**Project Number:** SP2018-007  
**Project Name:** Starbucks  
**Project Type:** SITE PLAN  
**Applicant Name:** MOORE WORTH INVESTMENTS, LLC  
**Owner Name:** MOORE WORTH INVESTMENTS, LLC  
**Project Description:**

## Project Plan Review History

**CITY OF ROCKWALL**  
**PLANNING AND ZONING COMMISSION MEMO**

**E1**

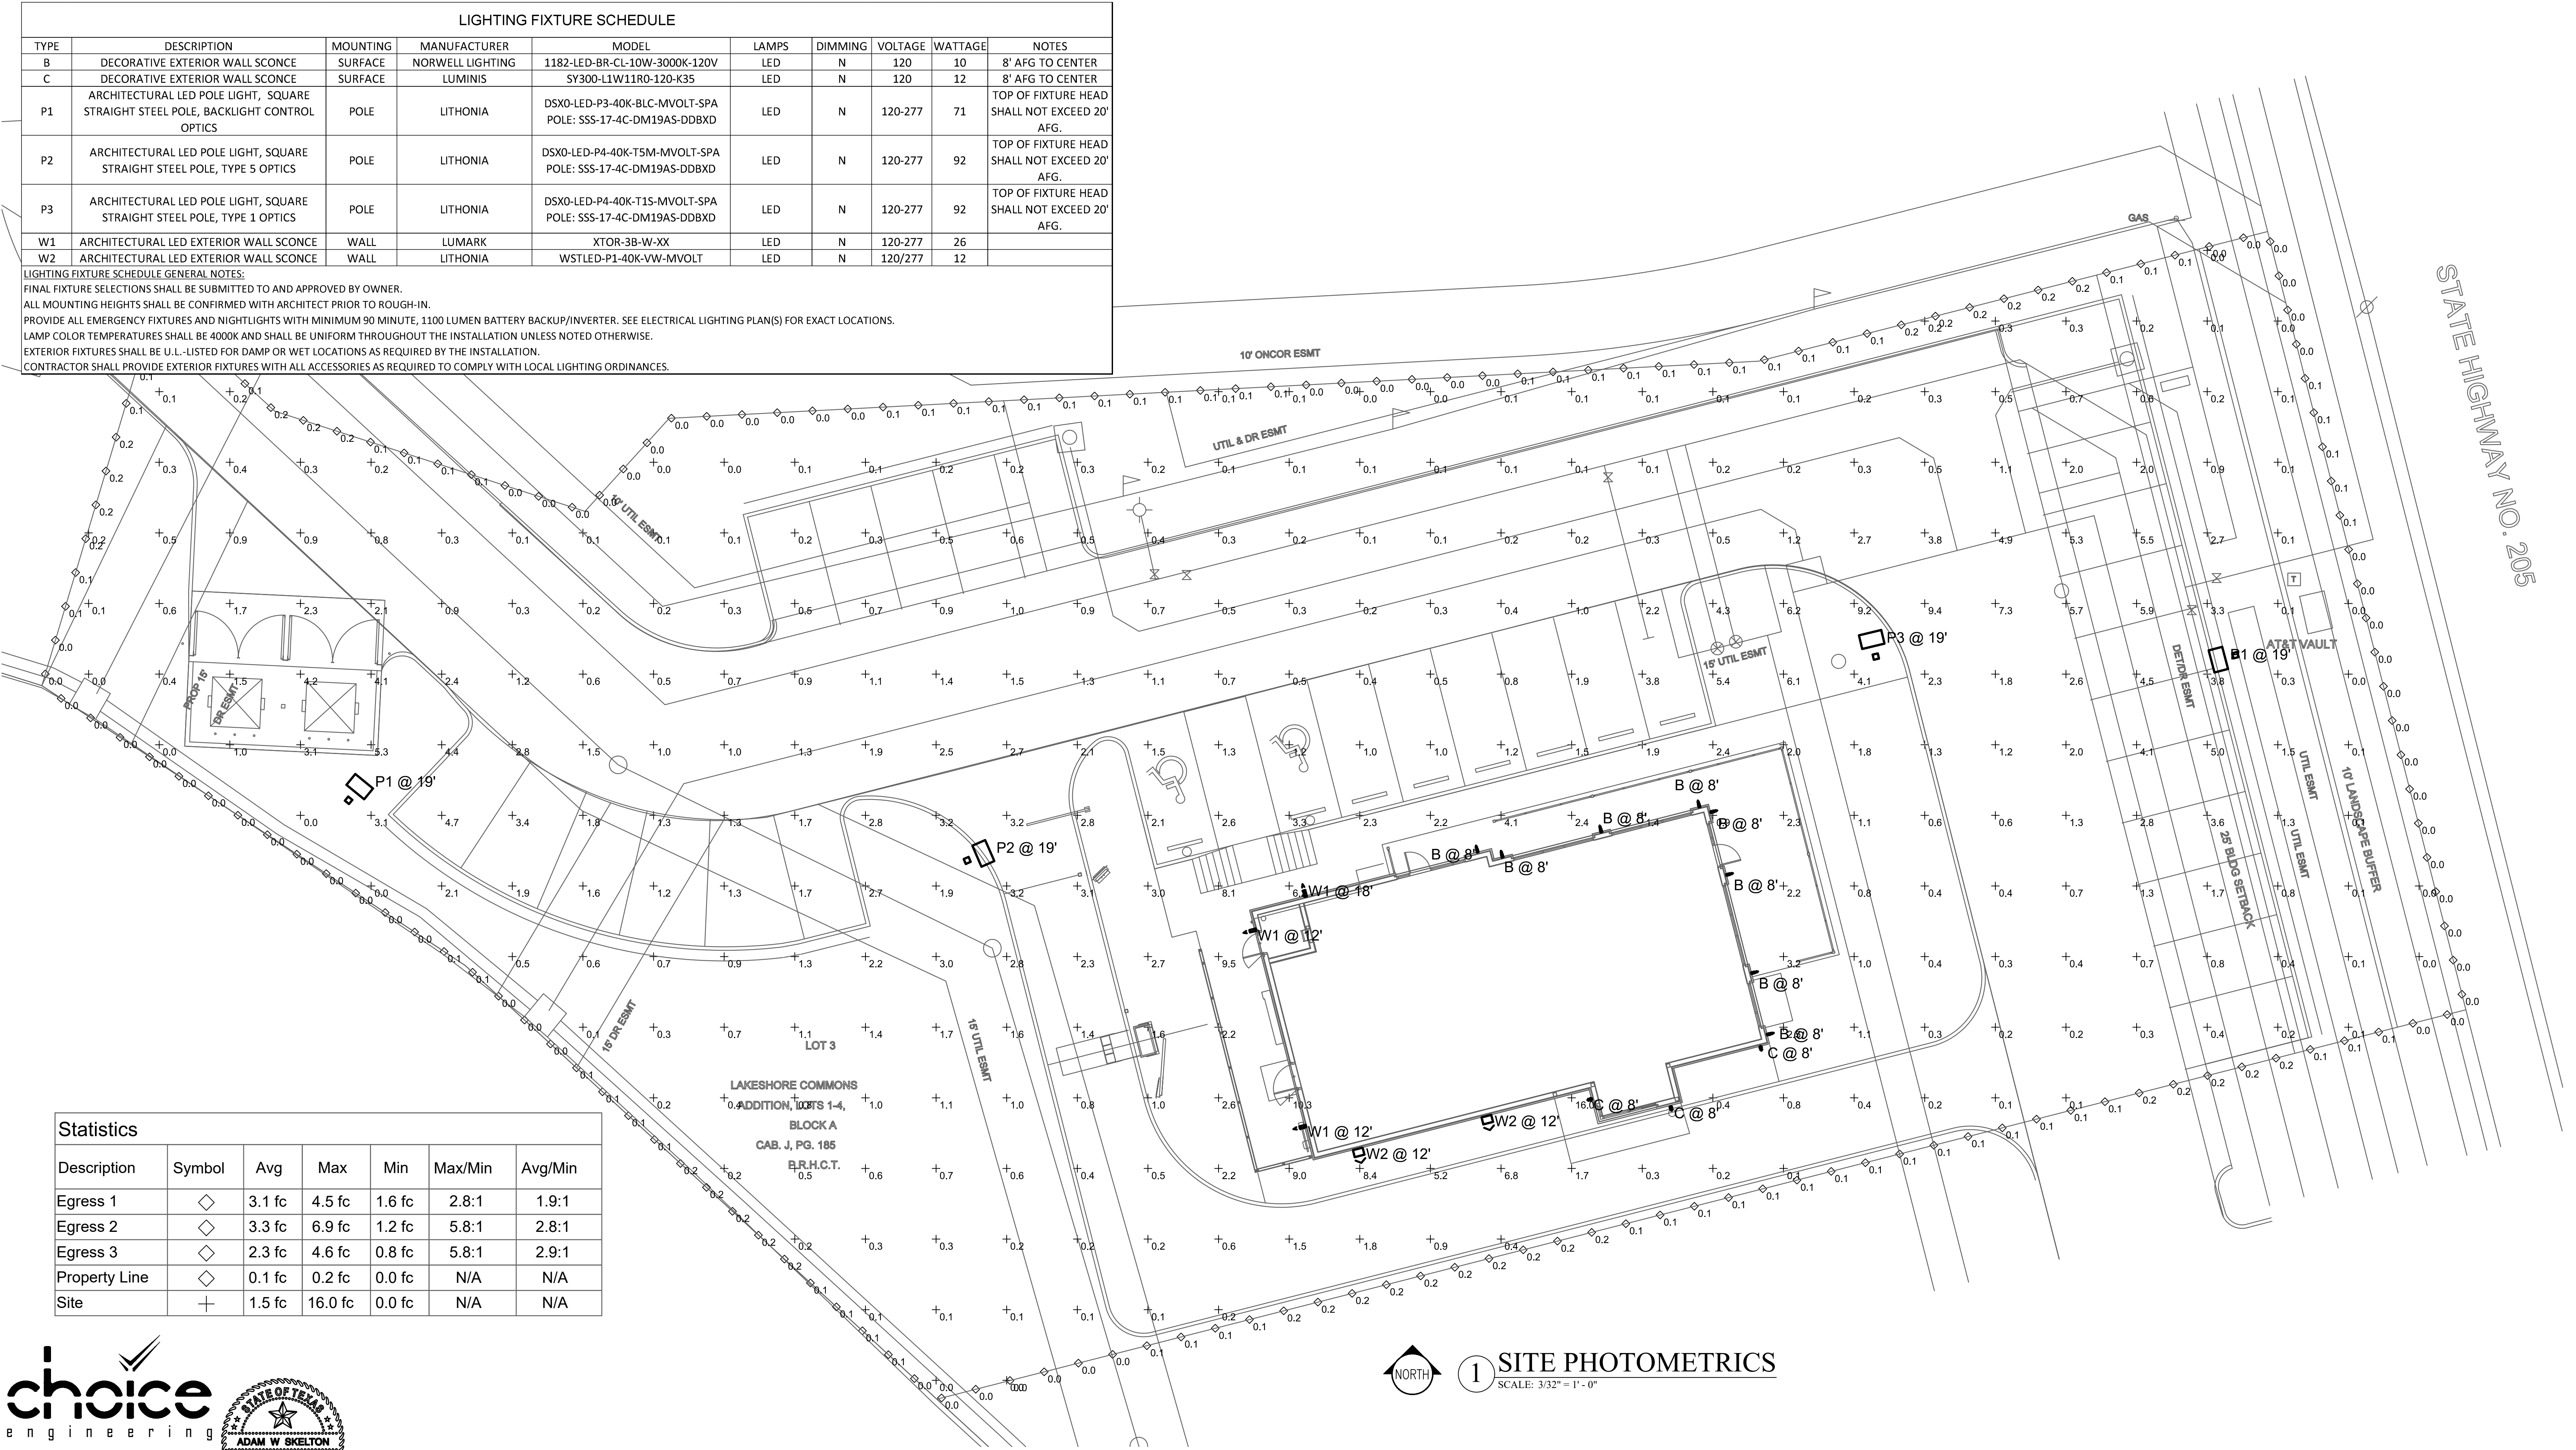
M.22	Landscape Plan. Please note that canopy trees are a min of 4 caliper-inches and not 3-3.5 caliper-inches as shown.					
M.23	Landscape Plan. Please note that the LS buffer is 20-feet not 10-feet.					
M.24	Photometric Plan. Please darken property line on photometric plan.					
M.25	Photometric Plan. Please provide some clarification on the symbols for "Egress 1, 2, 3, and Property Line"					
M.26	Photometric Plan. Please label cut sheet so that I can determine which cut sheet matches the fixture type on the photometric plan.					
M.27	Photometric Plan. Please note that any light over 15-watts shall be directed downward with a partial or full cutoff					
M.28	Photometric Plan. Please provide site data table as shown in site plan.					
M.29	Photometric Plan. Please show centerline of SH-205					
M.30	Building Elevations. Please note that the overlay district requires 8-foot dumpster enclosure. Please provide elevations of dumpster enclosure.

01 FRONT (EAST) ELEVATION

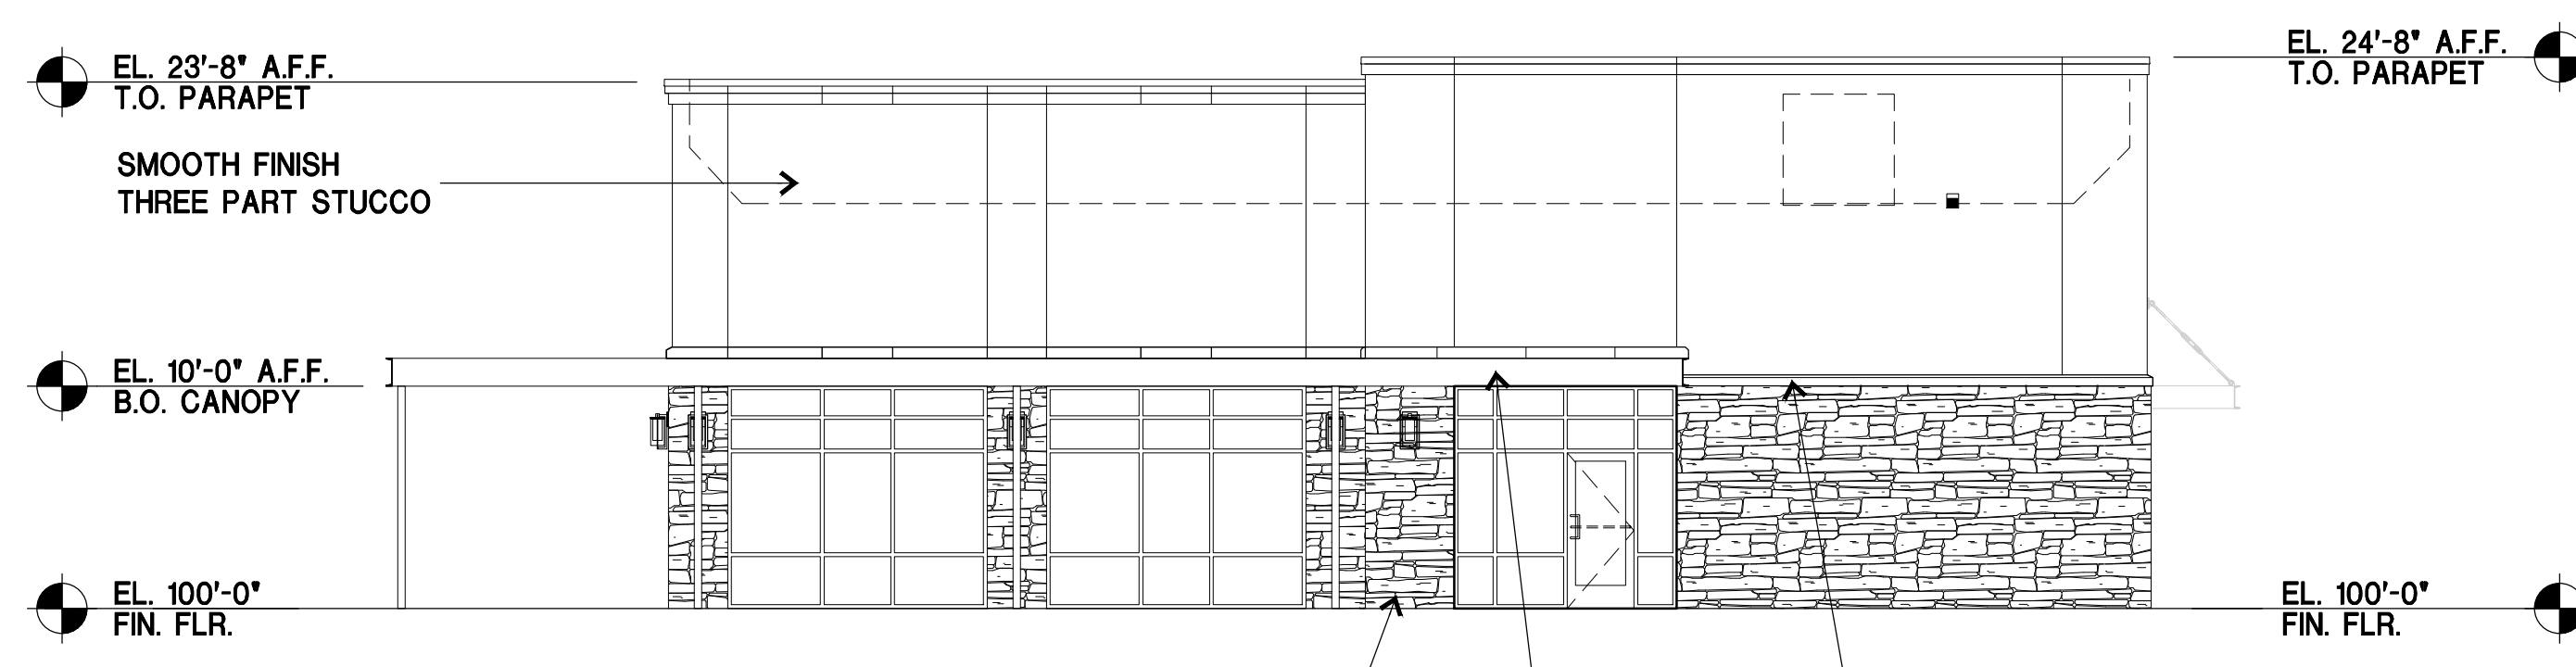
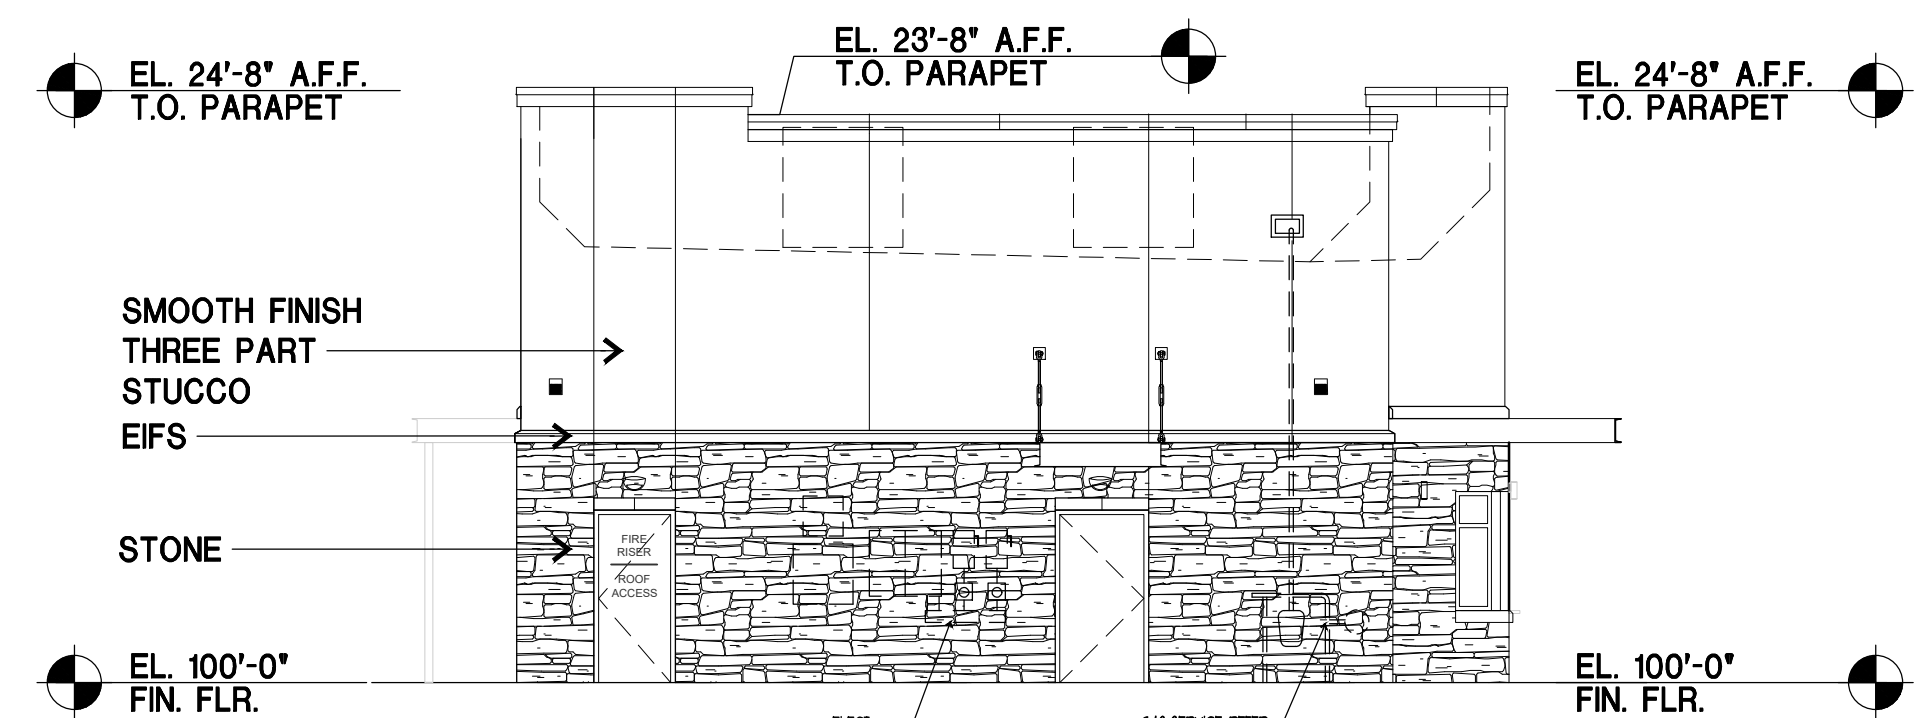
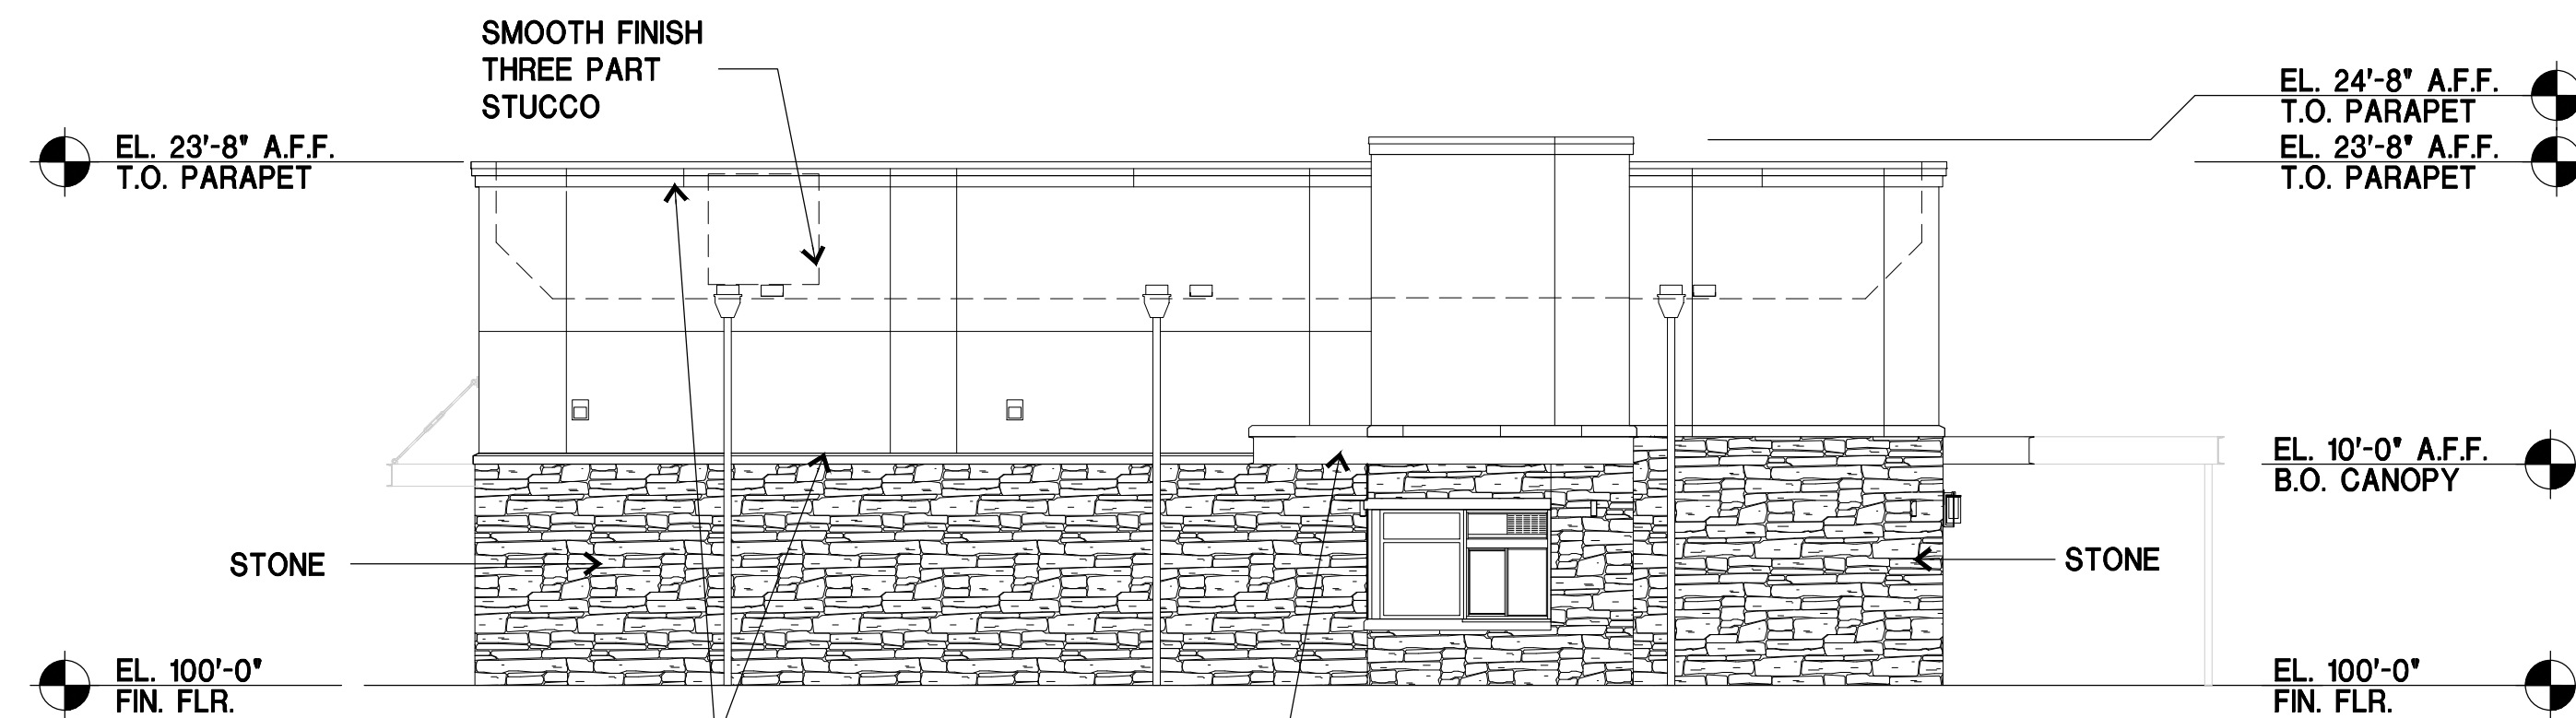
M.31	Building Elevations. Please note in an overlay district, natural or quarried stone is required. You are proposing cultured stone which would require approval of a variance.					
M.32	Building Elevations. Please remove metal canopies from building façade material percentages and re-calculate.					
M.33	Building Elevations. Please note that EIFS is a secondary material. Secondary materials over 10% per façade require a variance.					
M.34	Building Elevations. Please indicate the elevation that faces the street.					
M.35	Building Elevations. Note that stucco over 50% per façade will require a variance.

Type of Review / Notes	Contact	Sent	Due	Received	Elapsed Status	Remarks
M.36	Building Elevations.	Please note that this will require a variance to the pitched roof requirement. According to the UDC, any building less than 6,000 SF shall be constructed of a pitched roof system.				
M.37	Building Elevations.	Please provide a materials sample board.				
M.38	Building Elevations.	If the building elevations are scalable, please provide scale.				
I.39	The Architectural Review Board (ARB) meeting for this case will be held on March 27, 2018 at 5:00 p.m.					
I.40	Staff has identified the aforementioned items necessary to continue the submittal process. Please make these revisions and corrections, and provide any additional information that is requested. Revisions for this case will be due on April 3, 2018. The Planning and Zoning Worksession for this case will be March 27, at 6:00 p.m. The Planning and Zoning Meeting will be April 10, 2018. A representative is required to attend all meetings.
